## **PROPOSED AMENDMENTS TO ECE Regulations Nos. 112, 48, and 98**

# **JUSTIFICATION FOR THE PROPOSED AMENDMENTS TO ECE Regulations Nos. 112, 48, and 98**

**A. Headlamp for right-hand traffic (Proposed)**  
 (Dimension in mm with screen at 25 m distance)

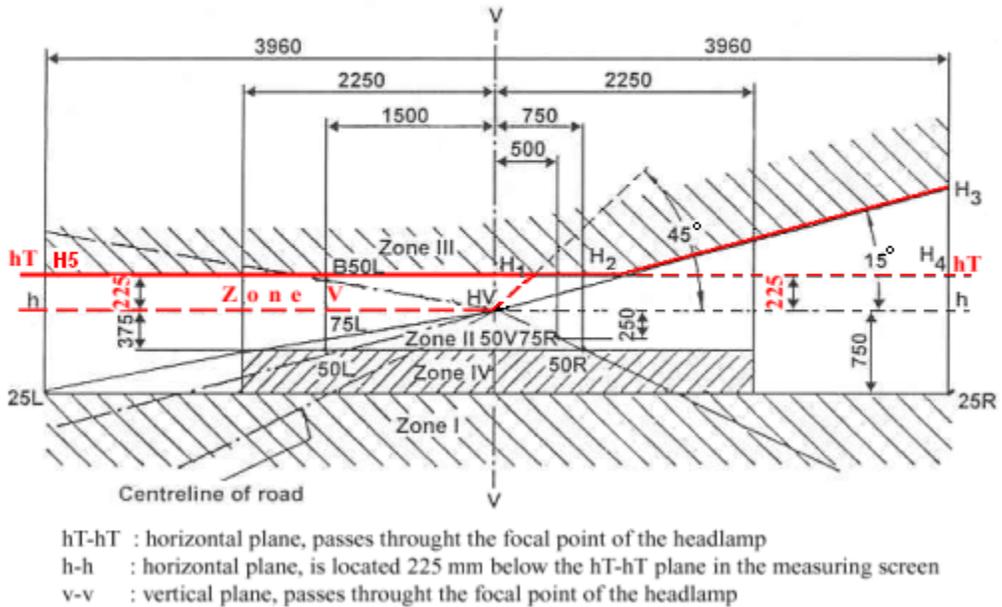
**6.2.1.** The passing beam must produce a sufficiently sharp "cut-off" to permit a satisfactory adjustment with its aid. The "cut-off" must be a horizontal straight line on the side opposite to the direction of the traffic for which the headlamp is intended; **on the other hand, it must not extend beyond either the hT- hT horizontal line, 22.5 cm above the straight line h-h, or the straight line HV H3, inclined at an angle of 15E above the horizontal (see annex 3). A cut-off extending beyond either line H5 H2 H3 or H5 H2 H4 shall in no circumstances be permitted.**

6.2.2.1. in the case of headlamps designed to meet the requirements of right-hand traffic, **the H2 H5 "cut-off", starting from Point H2, on the left-half of the screen is horizontal and, in the case of headlamps designed to meet the requirements of left-hand traffic, the H2 H5 "cut-off", starting from Point H2, on the right-half of the screen is horizontal, both on the hT- hT line.**

6.2.2.2. **Horizontal "cut-off" line, hT-hT, is situated on the screen 22.5 cm above the level h-h (see annex 3);**

ECE R112 Annex III, “cut-off lines” proposed for both right- and left-hand traffic are indicated in the proposed photometric measurement tables based on European standards.

Figure C: (Proposed)

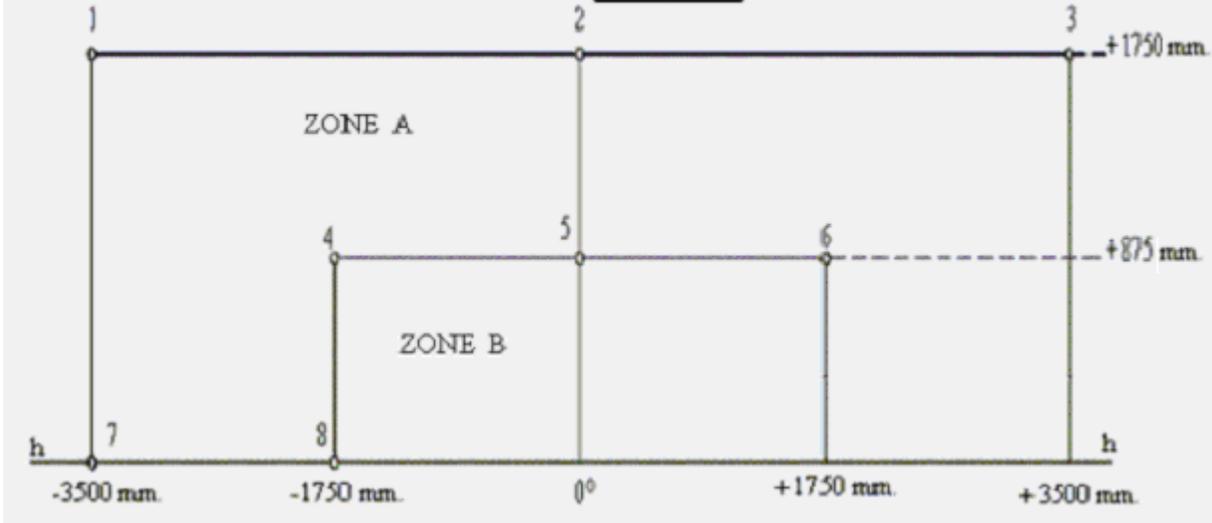
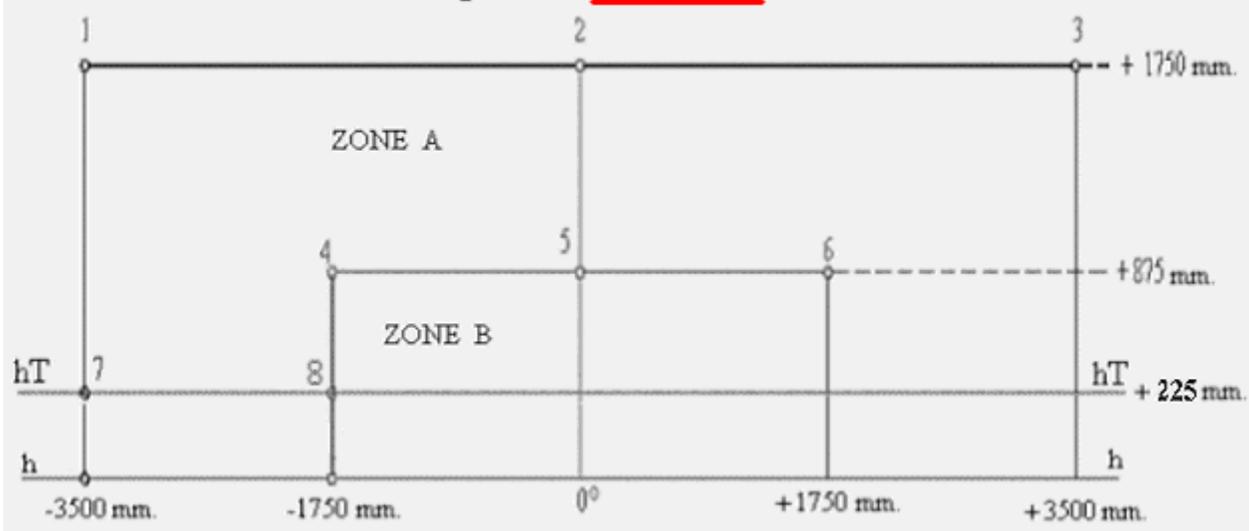
Figure C shows the measuring points for right-hand traffic. Points 7 and 8 move to their corresponding location at the right-hand side of the picture for left-hand traffic. Points 7 and 8 on the h-h line and in the original Figure C are on the hT-hT plane 225 mm upwards the h-h plane in the proposed Figure C. Area under the hT-hT line is the illumination zone.

In ECE R112 Annex III Figure C, hT-hT horizontal line and points 7 and 8 are 225 mm upwards the h-h line along the v-v axis.

## Annex 7, (Proposed)

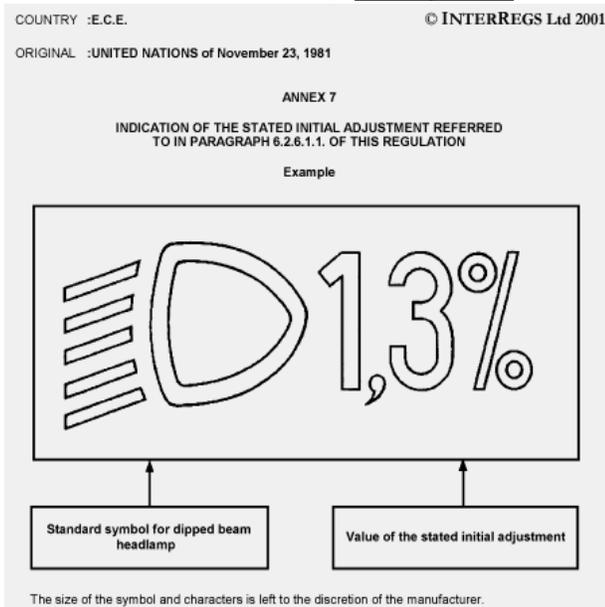
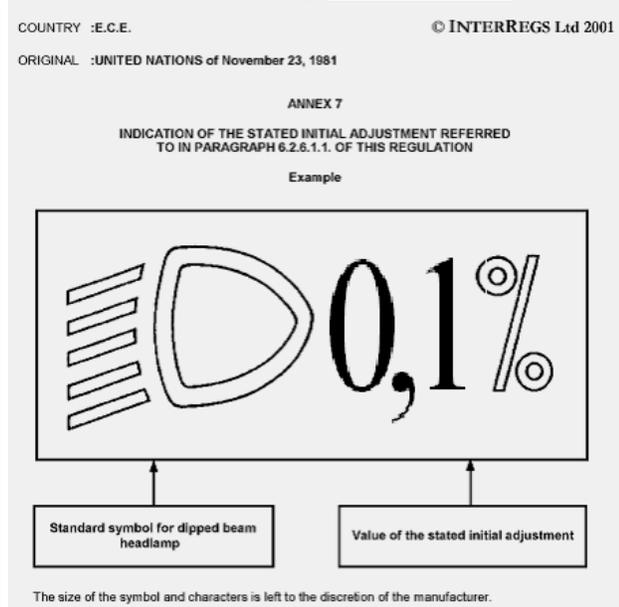
**Annex 7 - Proposed:** In Annex 7 of ECE R48, The “Standard symbol for dipped beam headlamp”, “Value of the stated initial adjustment”, 1.3%, for the unladen vehicle has been changed to 0.1% .

“Standard symbol for dipped beam headlamp”, “Value of the stated initial adjustment” in ECE R48 Annex 7, 1.3 %, which is the initial light beam inclination angle of the passing beam in unladen vehicles has been changed as 0.1 % to comply with the proposed amendments.

**ECE R98      Annex 3**  
**Figure A : Measuring screen 1 (Proposed)**

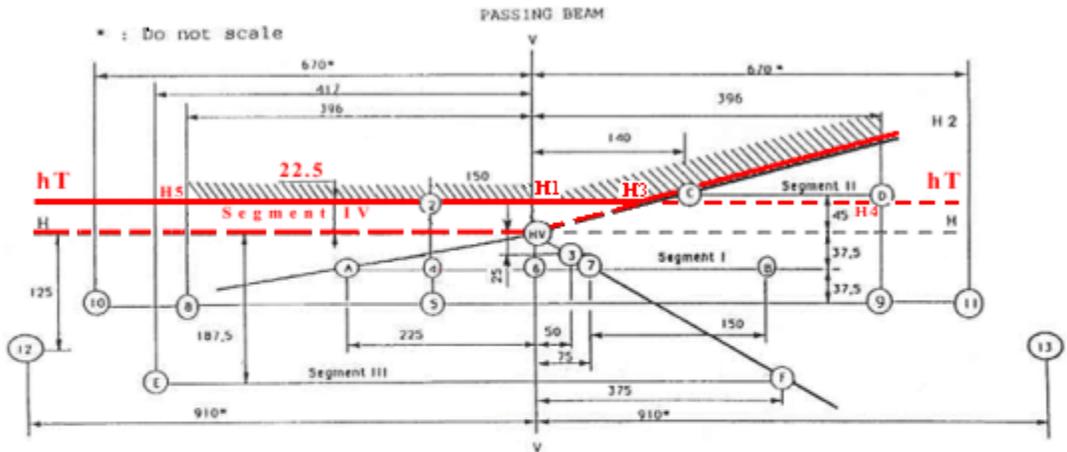
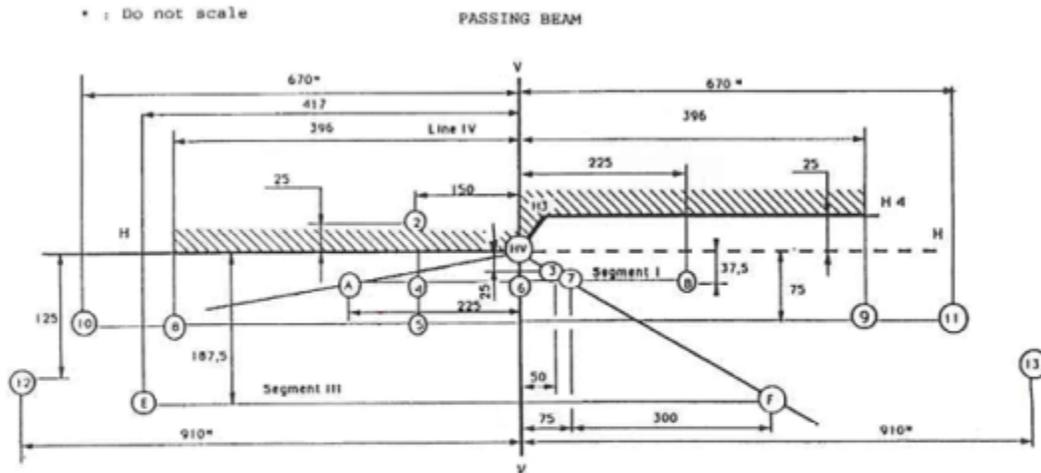
The passing beam must produce a sufficiently sharp "cut-off" to permit a satisfactory adjustment with its aid. The "cut-off" must be a horizontal straight line on the side opposite to the direction of the traffic for which the headlamp is intended; **on the other hand, it must not extend beyond either the hT-hT horizontal line, 22.5 cm above the straight line H-H, passing through Points 2, and H5, H3, H4, or above the straight line H3 H2, inclined at an angle of 15° above the horizontal (see annex 3). A cut-off extending beyond line H5 H3 H2 shall in no circumstances be permitted.**

in the case of headlamps designed to meet the requirements of right-hand traffic, **the H3 H5 "cut-off", starting from Point H3, on the left-half of the screen is horizontal and, in the case of headlamps designed to meet the requirements of left-hand traffic, the H3 H5 "cut-off", starting from Point H3, on the right-half of the screen is horizontal, both being on the hT-hT line.**

Dimensions are in cm on a flat vertical screen at 25 m. The HH and VV lines are the intersections with this screen of the horizontal and vertical planes passing through the axis of reference of the passing beam as declared by the applicant. The above screen describes a right-hand traffic passing beam. The screen for left-hand traffic passing beam is mirrored about the VV line. Angle H3 H2 - hT hT = 15°

**H-H** : horizontal plane  
**v-v** : vertical plane  
**hT-hT** : the proposed horizontal line, which is at the level of the focal point of the headlamp, and 22.5 cm above the H-H plane.

No type of the “cut-off line” of the passing beam system (Annex 3, Figure A and B) according to ECE R98 can provide sufficient illumination for the left-hand side in the right-hand traffic system, or vice versa. In the standard passing beam illumination systems with a cut-off inclination of 1%, when the entire road is considered, the illumination distance that can be achieved is about 25-30 meters. On the other hand, when the illumination distance is increased manually or by means of electronic devices, to increase the illumination distance, the dazzling effect on the side opposite to the direction of the traffic is increased, and even temporary blindness may be caused, and this may cause many traffic accidents. The proposed “cut-off line” can provide illumination in the safe braking distance, without causing any dazzling effect on the side opposite to the direction of the traffic, and enables safe and comfortable night drives.

No type of the “cut-off line” of the passing beam system (Annex 3, Figure A and B) based on ECE R98 can provide sufficient illumination in the safe braking distance for the left-hand side in the right-hand traffic system, or vice versa. The proposed “cut-off line” can provide illumination of the safe braking distance, without causing any dazzling effect on the side opposite to the direction of the traffic, and enables safe and comfortable night drives.

**ECE R98      Annex 3**  
**Figure B : Measuring screen 2 (Proposed)**

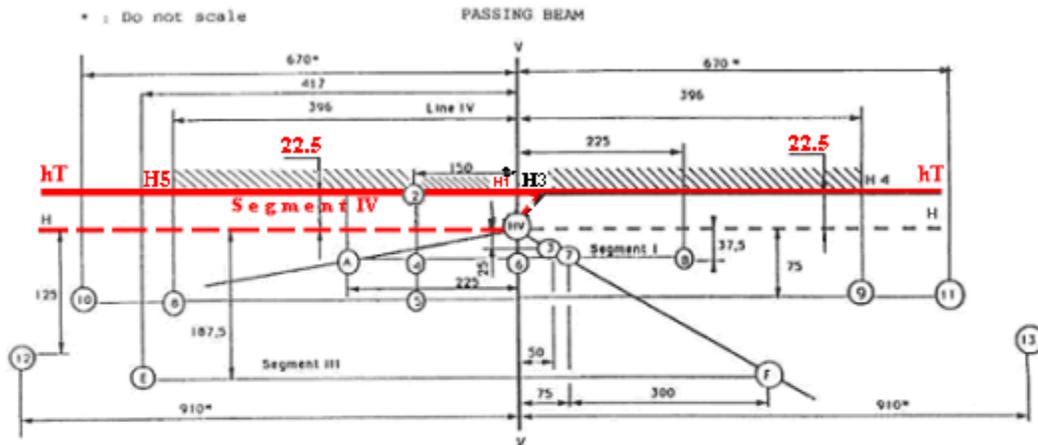
The passing beam must produce a sufficiently sharp "cut-off" to permit a satisfactory adjustment with its aid. The "cut-off" must be a horizontal straight line on the side opposite to the direction of the traffic for which the headlamp is intended; **on the other hand, it must not extend beyond the hT- hT horizontal line, 22.5 cm above the straight line H-H, passing through points 2, and H5, H3, H4, (see annex 3). A cut-off extending beyond straight line H5 H3 H4 (hT-hT horizontal line) shall in no circumstances be permitted.**

**in the case of headlamps designed to meet the requirements of right-, and left-hand traffic, H5 H3 H4 "cut-off ", on the whole screen is horizontal, on the hT-hT line.**

Dimensions are in cm on a flat vertical screen at 25 m. The HH and VV lines are the intersections with this screen of the horizontal and vertical planes passing through the axis of reference of the passing beam as declared by the applicant. The above screen describes a right-hand traffic passing beam. The screen for left-hand traffic passing beam is mirrored about the VV line. Angle H5 H3 - H3 H4 = 0°

**H-H** : horizontal plane  
**v-v** : vertical plane  
**hT-hT** : the proposed horizontal line, which is at the level of the focal point of the headlamp, and 22.5 cm above the H-H plane.

Figure C (Proposed) : Measuring points for illumination values

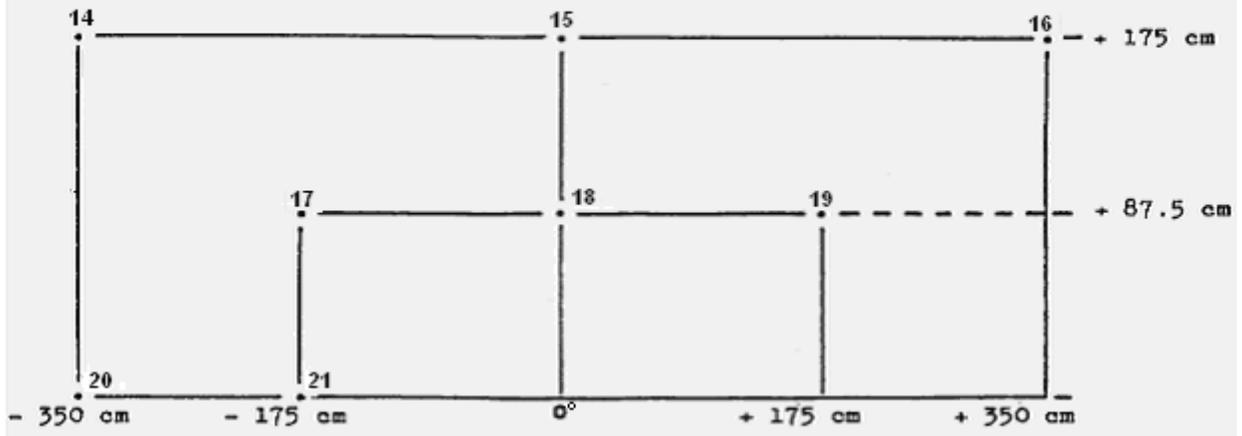
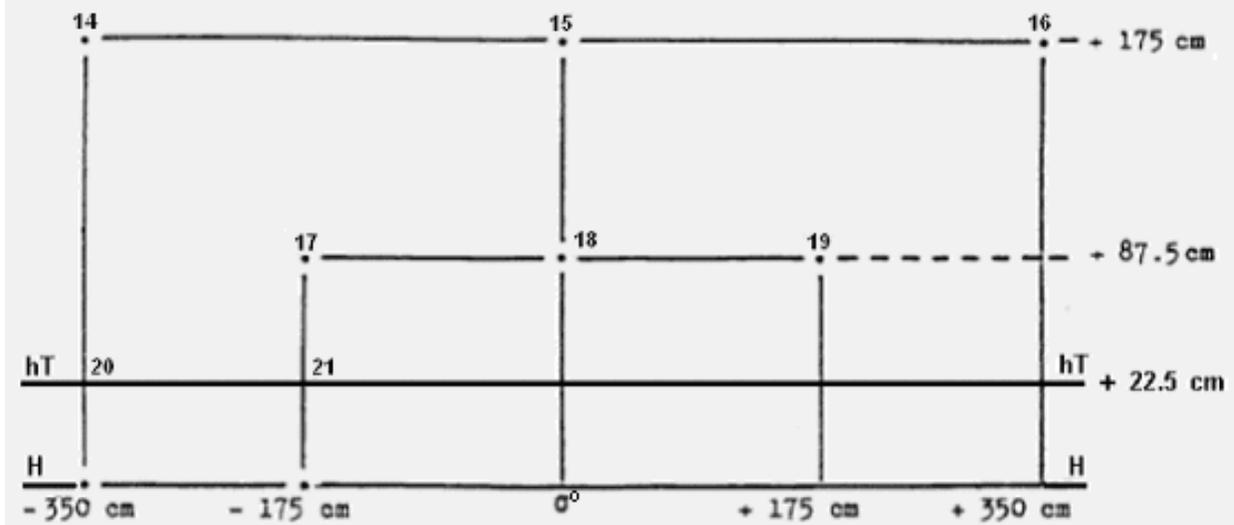
Figure C shows the measuring points for right-hand traffic. Points 20 and 21 move to their corresponding location at the right-hand side of the picture for left-hand traffic. Points 20 and 21 on the H-H line in the standard Figure C are on the hT-hT plane, 22.5 cm upwards to H-H plane in the proposed Figure C. Area under hT-hT line is the illumination zone.

In ECE R98 Annex III Figure C, hT-hT horizontal line and points 20 and 21 are 22.5 cm upwards the H-H line along the v-v axis.
